MERIDIAN STORAGE, LLC
MERIDIAN STORAGE

FALCON RANCHETTES FILING NO. 2, NORTH HALF OF THE SOUTHEAST QUARTER OF SECTION 12
TOWNSHIP 13 SOUTH, RANGE 65 WEST OF THE 6TH P.M., COUNTY OF EL PASO
STATE OF COLORADO, MERIDIAN ROAD & OWL PLACE

CONSTRUCTION DRAWINGS

SF-23-XXX Add PCD File #VR239

SIGNING AND STRIPING NOTES

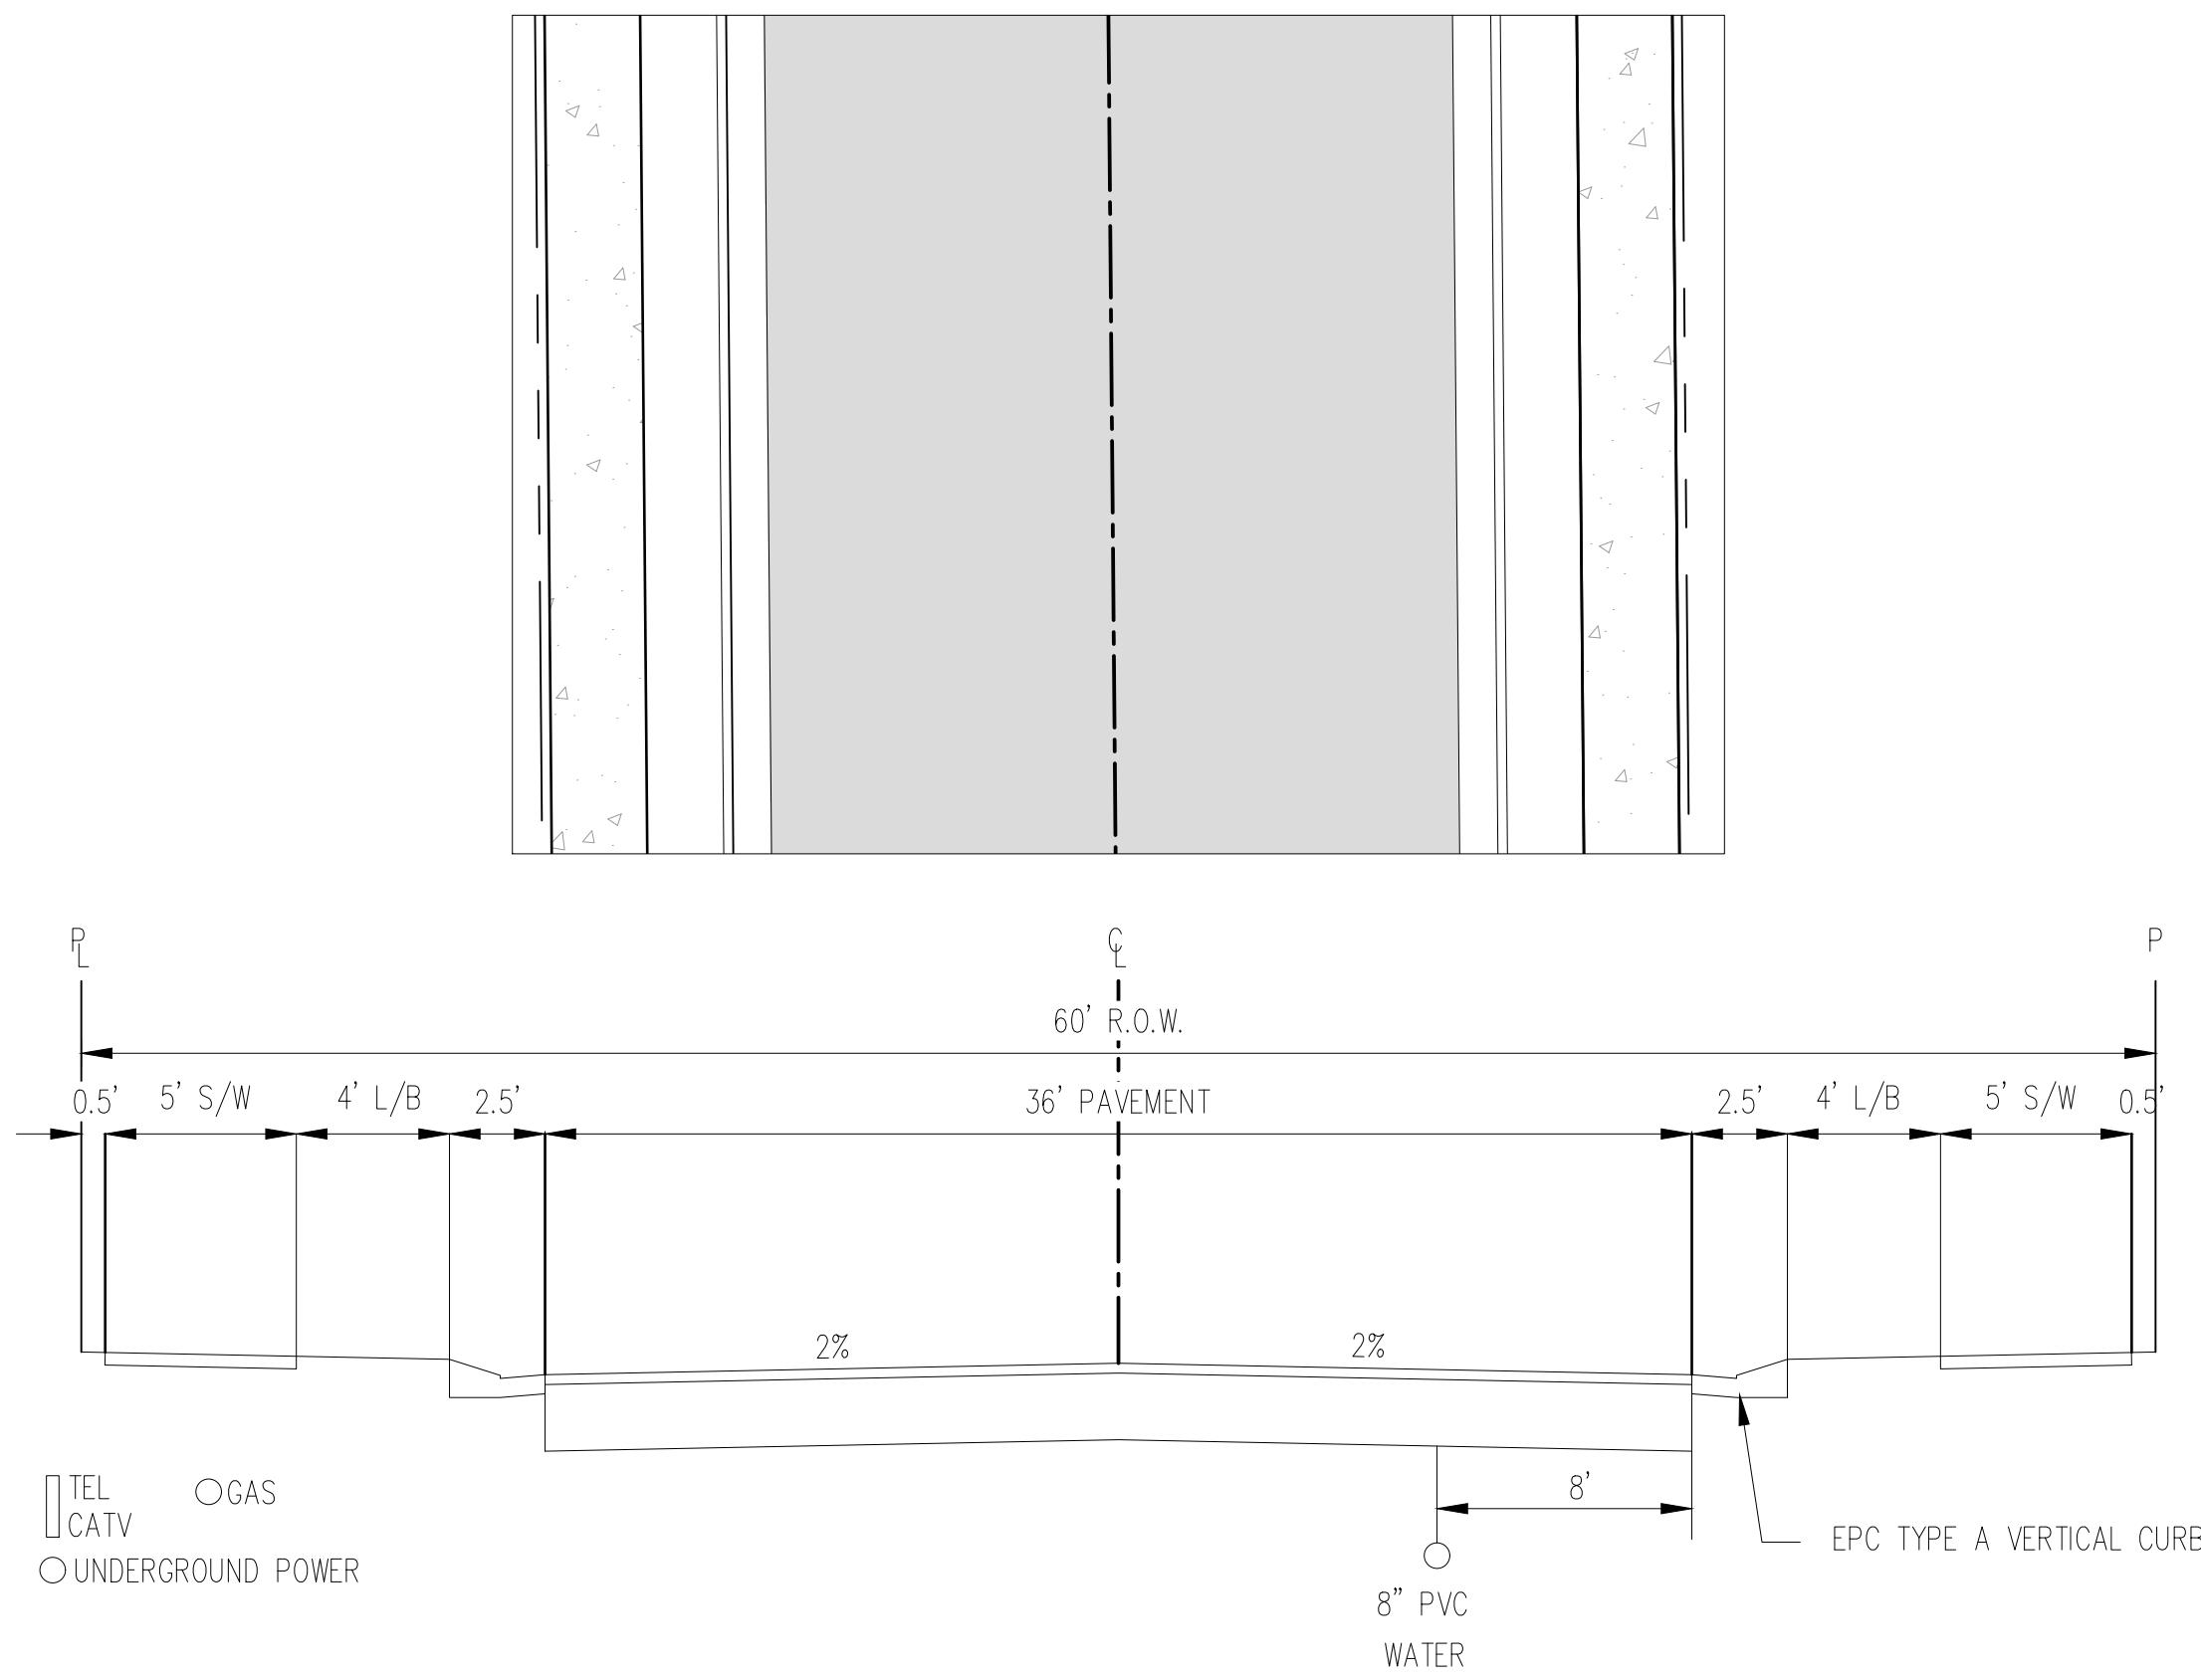
Add design and posted speed note 25/25mph

EXISTING CONDITIONS & DEMO PLAN

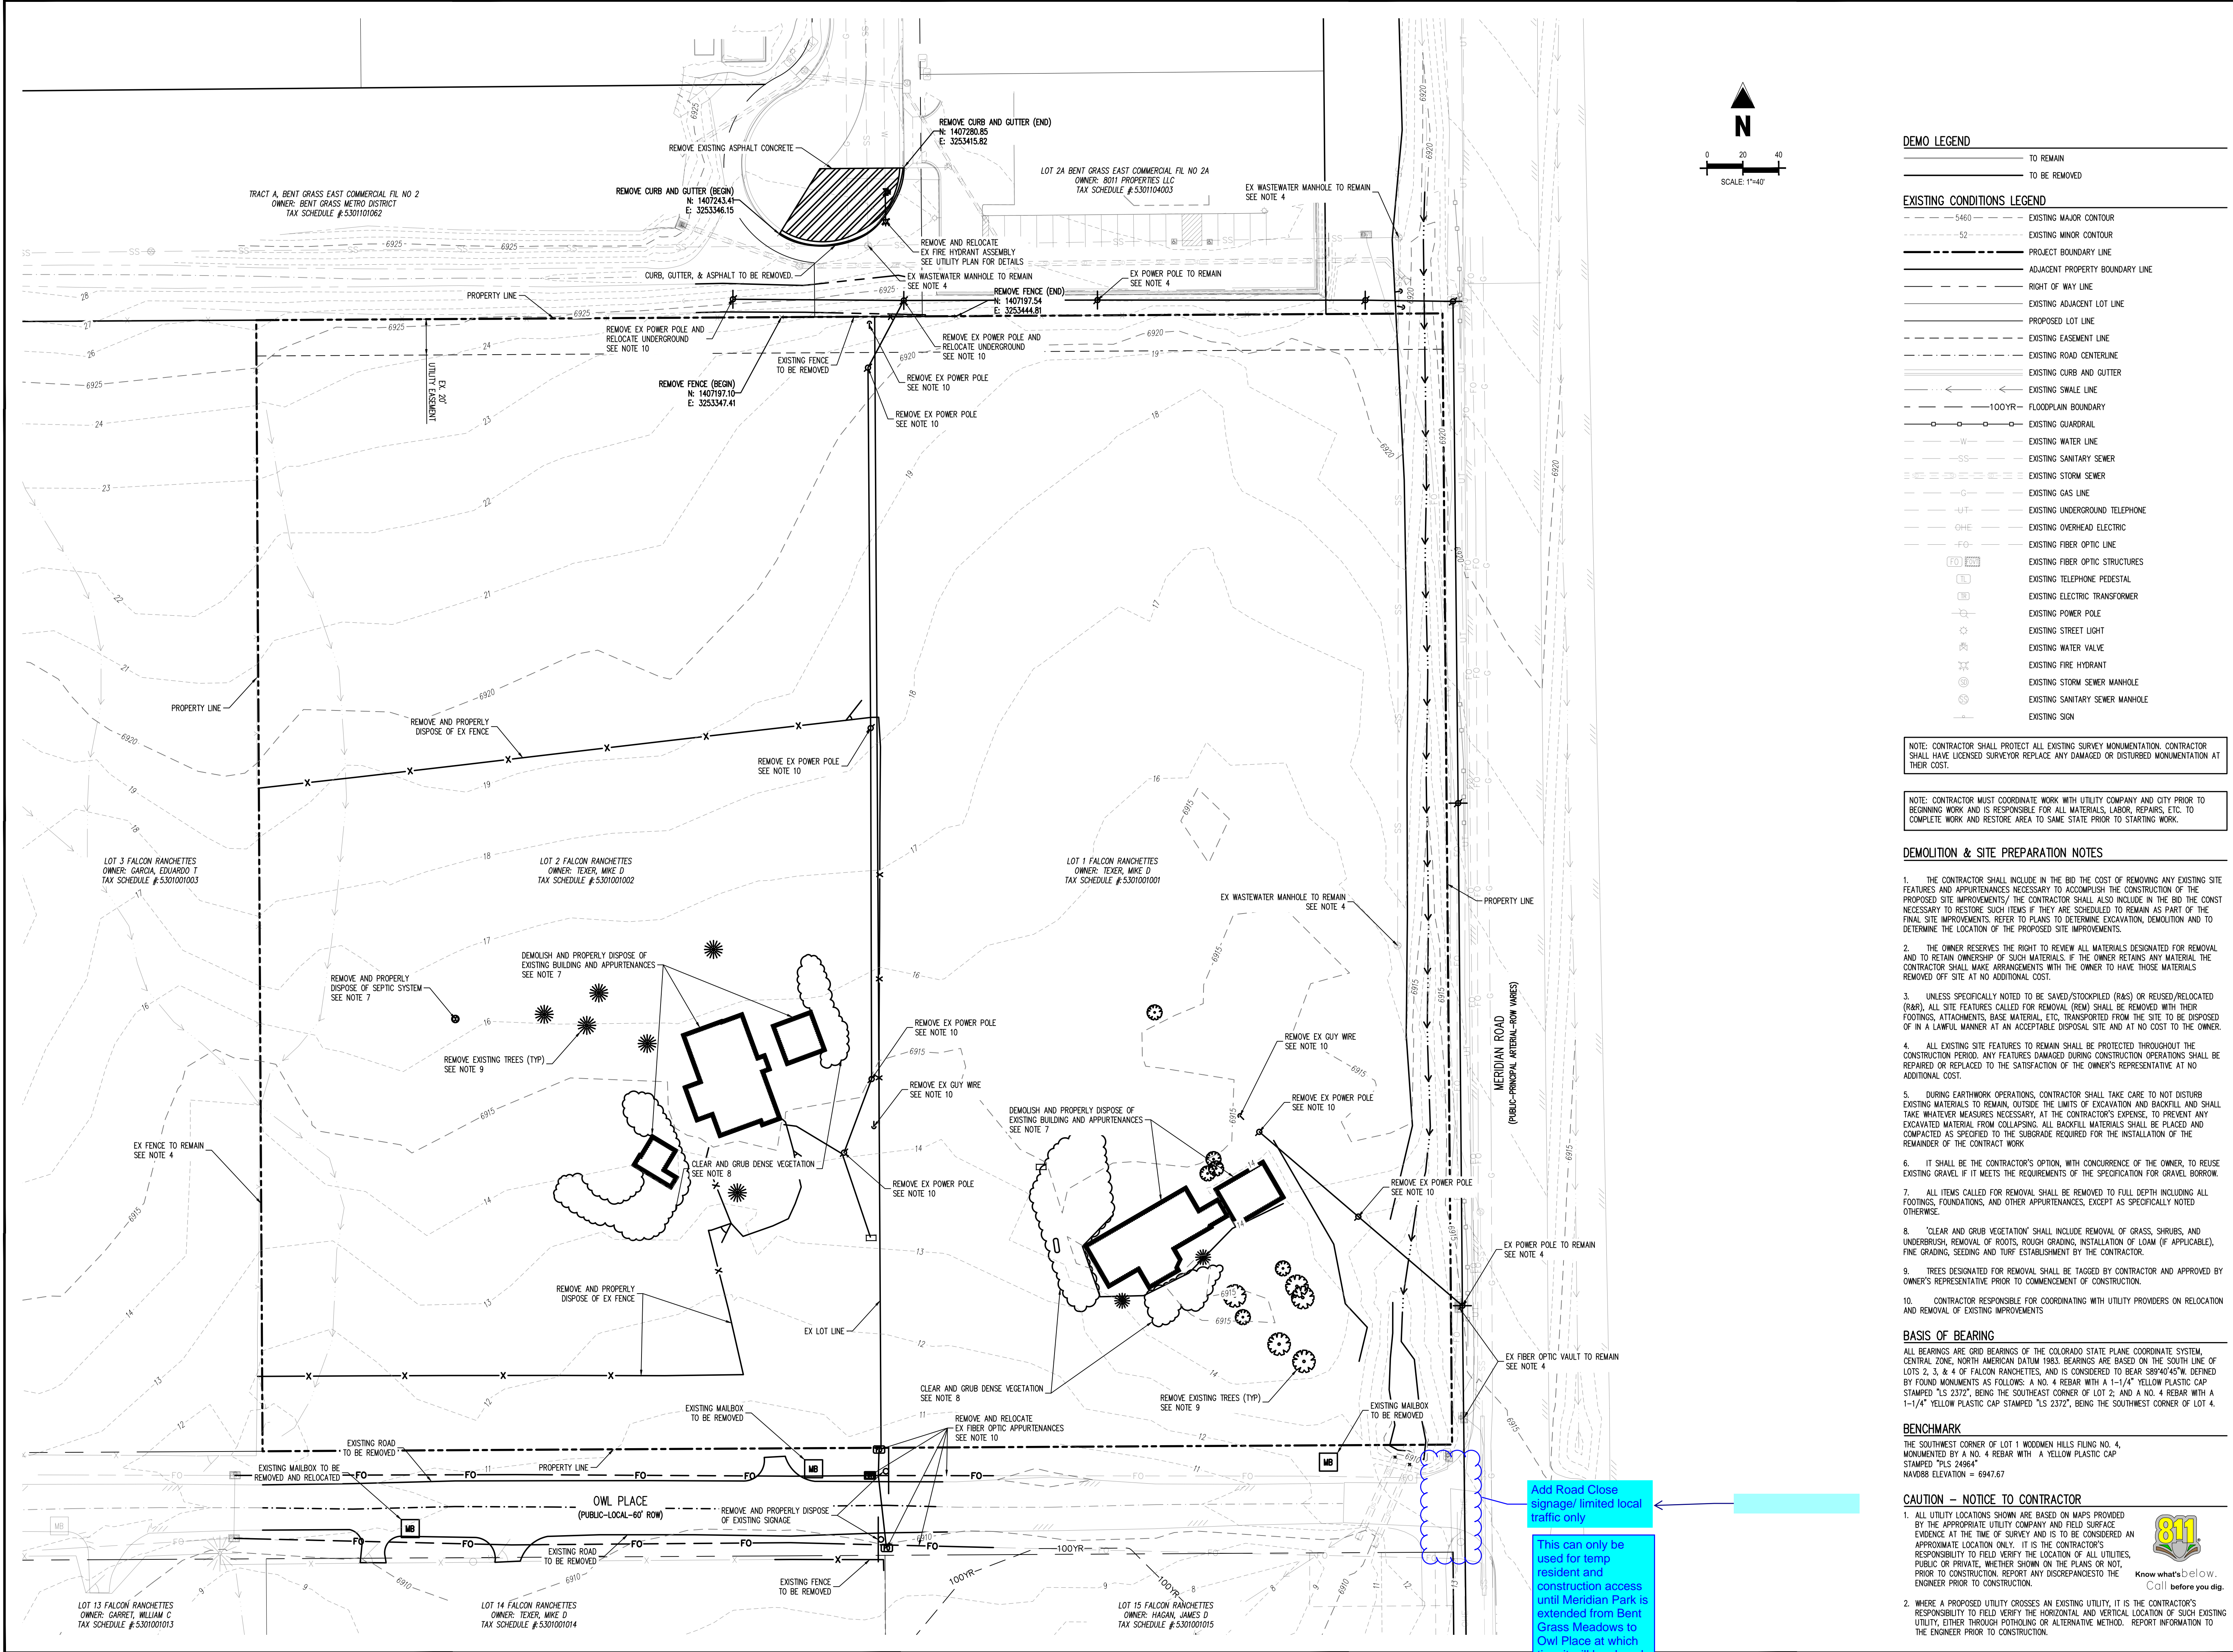
Add Road Close signage/ limited local traffic only

SITE PLAN

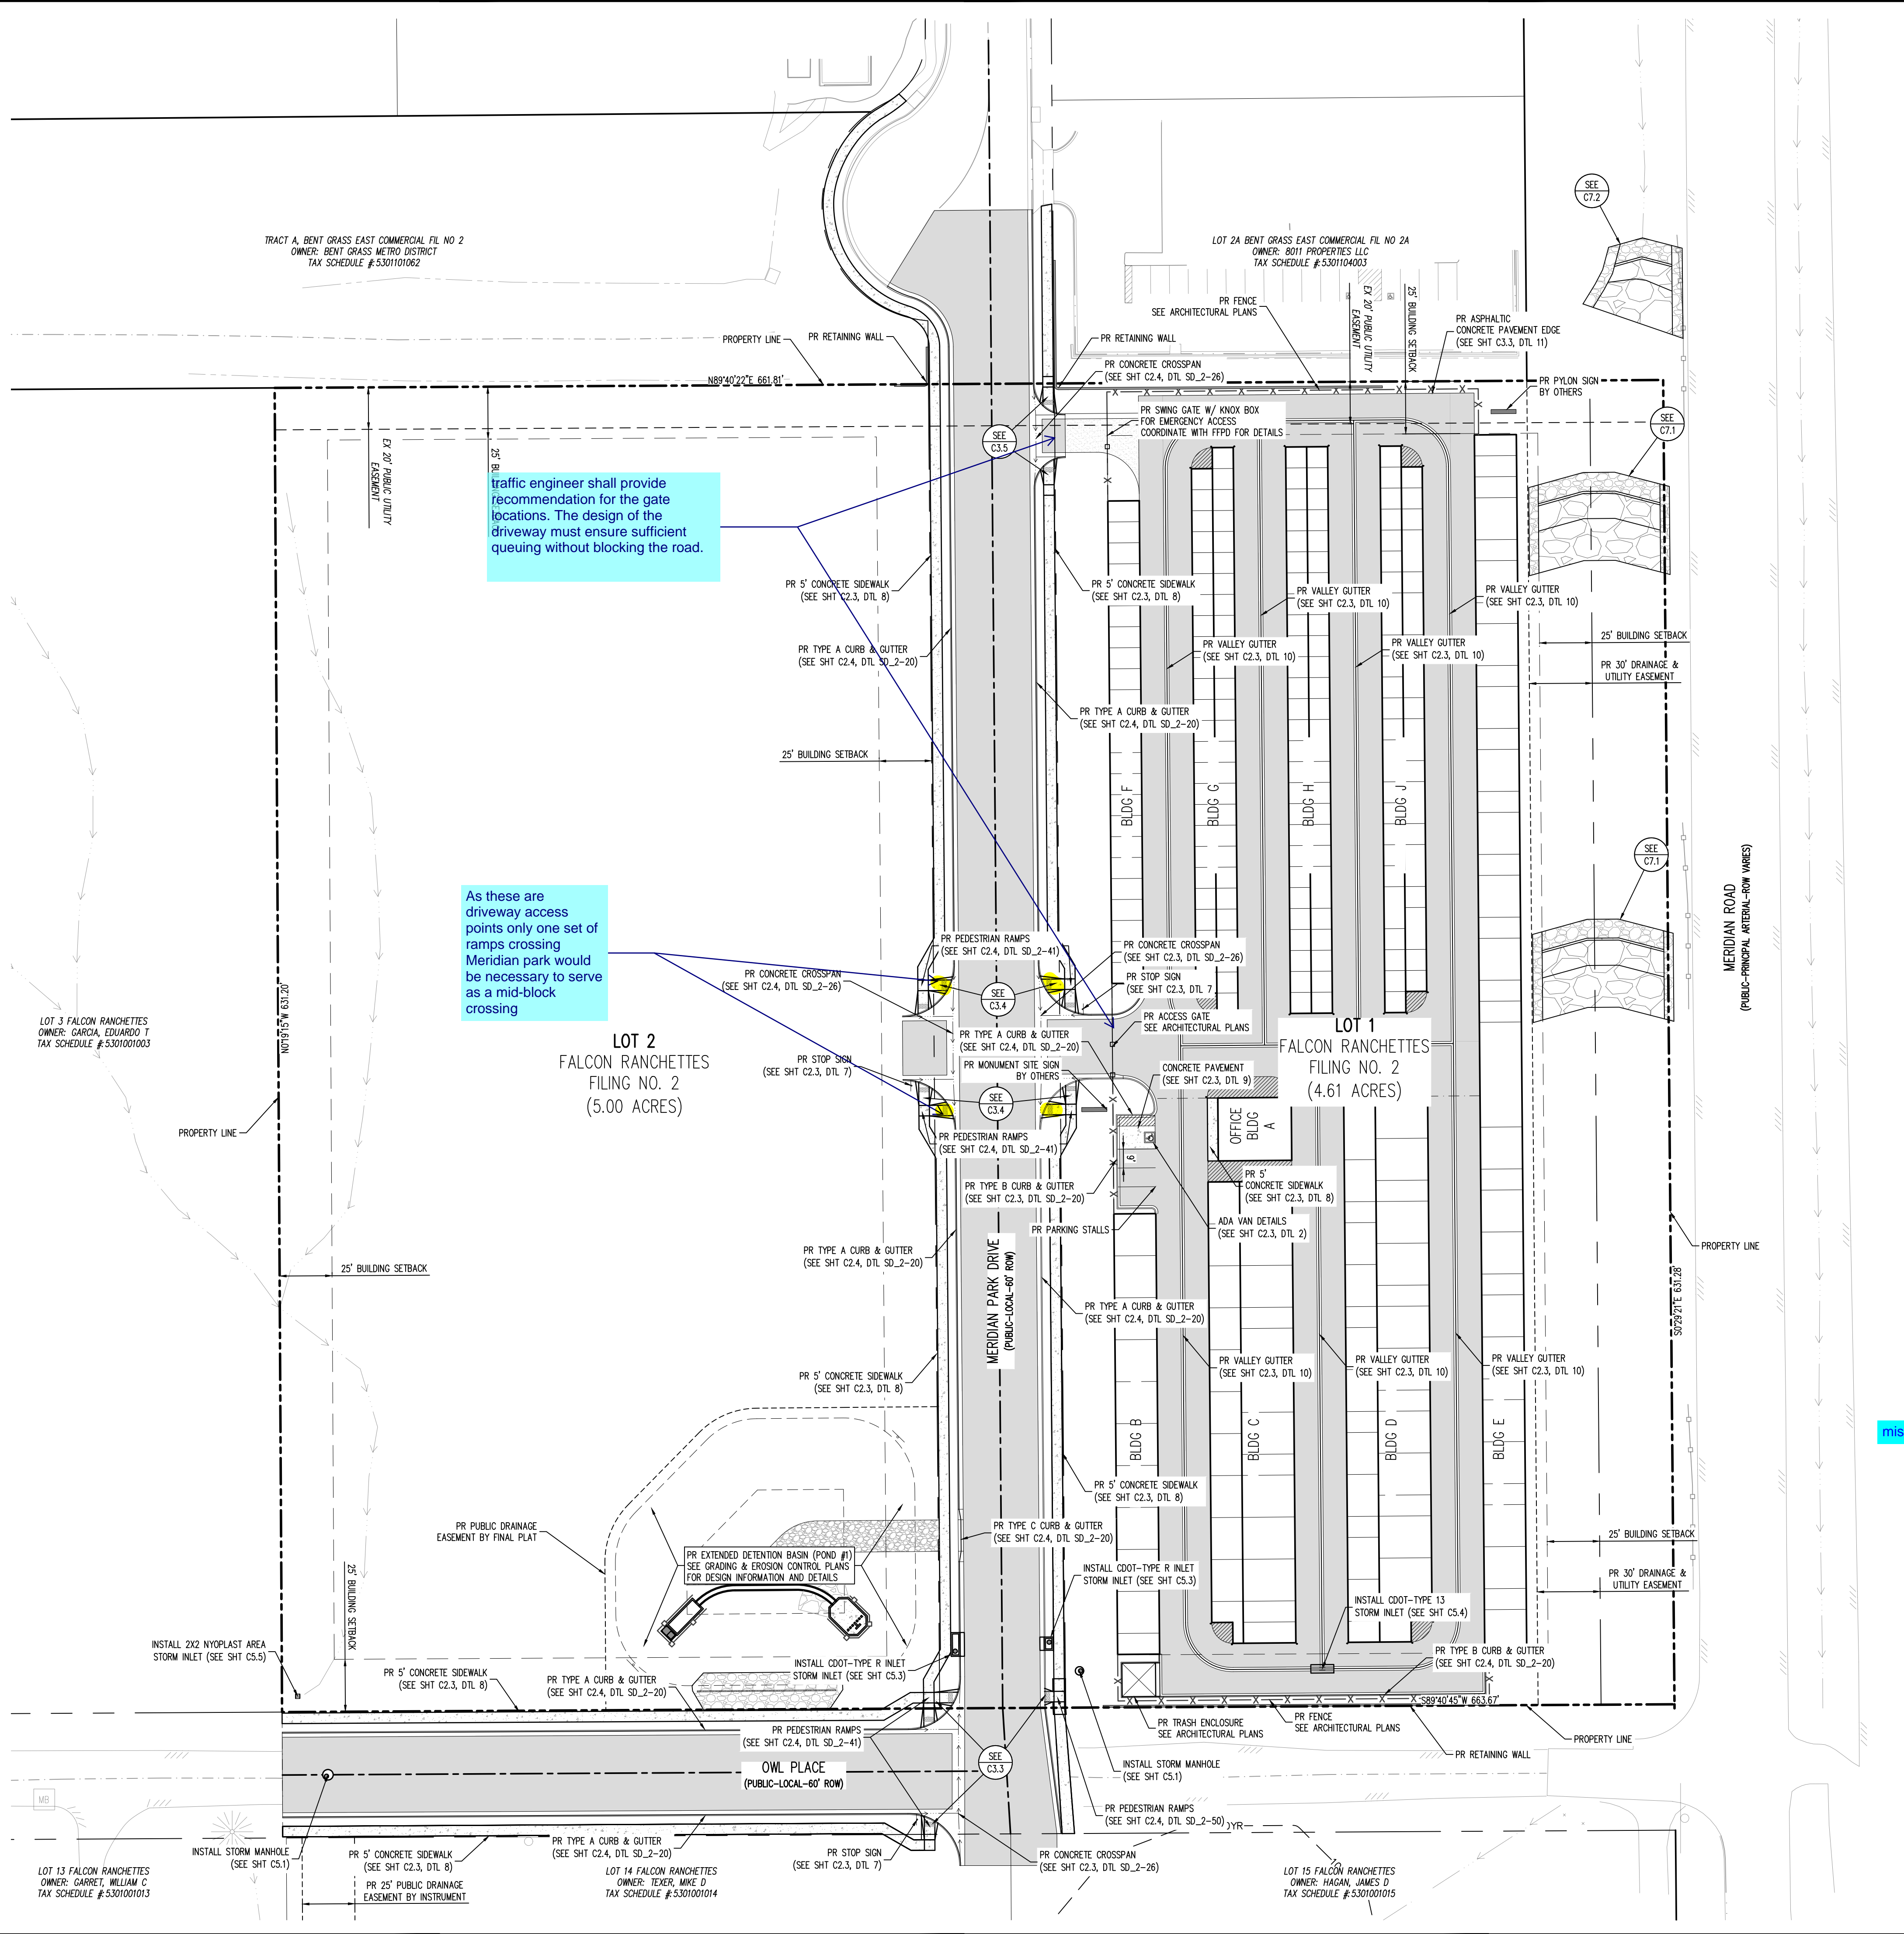
traffic engineer shall provide recommendation for the gate locations. The design of the driveway must ensure sufficient queuing without blocking the road.

As these are driveway access points only one set of ramps crossing Meridian park would be necessary to serve as a mid-block crossing
